Access Compliance Report Public Rights-of-Way (Curb Ramps)

Main Street: N_OCEAN_VIEW_ST Cross Street: BIXBY_AVE Location: NE

ADA ID: RPAT210924122642 Ramp Type: Type 6 - Directional 1 Initial Pass/Fail: Fail Overall Compliance: No Severity Score: 60

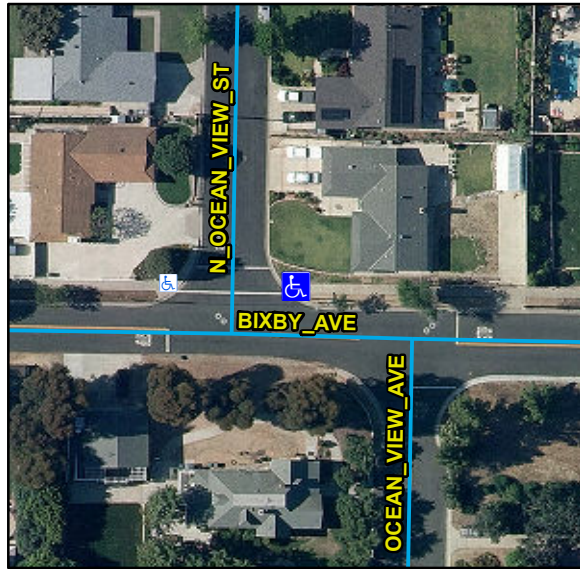
Compliance	Description	Data	Compliance	Description	Data
N/A	Ramp Length (in)	93	N/A	Flare Type LT	
Yes	Ramp Width (in)	48			N/A
No	Ramp Run Slope (%)	13.4	N/A	Flare Slope LT (%)	N/A
No	Ramp Cross Slope (%)	8	N/A	Flare Traversable LT	N/A
N/A	Grade Break	N/A	N/A	Flare Type RT	
N/A	Grade Break Slope (%)	N/A			N/A
N/A	Grade Break Cross Slope (%)	N/A	N/A	Flare Slope RT (%)	N/A
	Addl Para Ramp Left?	No	N/A	Flare Traversable RT	N/A
	Addl Para Ramp Right?	No	N/A	DWS Provided	N/A
N/A	Landing Present	N/A	N/A	DWS Contrast	N/A
N/A	Landing Length (in)	N/A	N/A	DWS Length (in)	N/A
N/A	Landing Width (in)	N/A	N/A	DWS Full Width	N/A
N/A	Landing Run Slope (%)	N/A		DWS Offset Type	N/A
N/A	Landing Cross Slope (%)	N/A	N/A	DWS Left Offset (in)	N/A
N/A	Landing Movement Obstructed?	N/A	N/A	DWS Right Offset (in)	N/A
	Landing Movement Type	N/A			
N/A	Landing Shared	N/A			
N/A	Marked Crosswalk 1	Yes	N/A	Clear Space	N/A
	Crossing 1 Direction	E	N/A	Clear Space To Crosswalk (in)	N/A

Marked Crosswalk 1 Width (in)	120			
N/A	Ramp Inside Crosswalk 1	No			
	Crossing 1 Slope (%)	0.3			
	Crossing 1 Cross Slope (%)	7.7			
N/A	Gutter Ponding	N/A	N/A	Curb Slope	4.6
Yes	Gutter Lip Height (in)	0		Road Run Slope (%)	N/A
N/A	Gutter Run Slope (%)	N/A		Road Cross Slope (%)	N/A
N/A	Gutter Cross Slope (%)	N/A		Parallel Ramp Side	N/A
Yes	Overall Surface Condition	Acceptable	No	Perp Joint Present	No
	Cross Gutter Present?	No		Spandrel Present?	No
	Replace Cross Gutter?	N/A		Replace Spandrel?	N/A

Remove & Replace Entire Ramp. Restripe Crosswalk.

R204.3, R304.2.2, R304.5.3, STD 1115
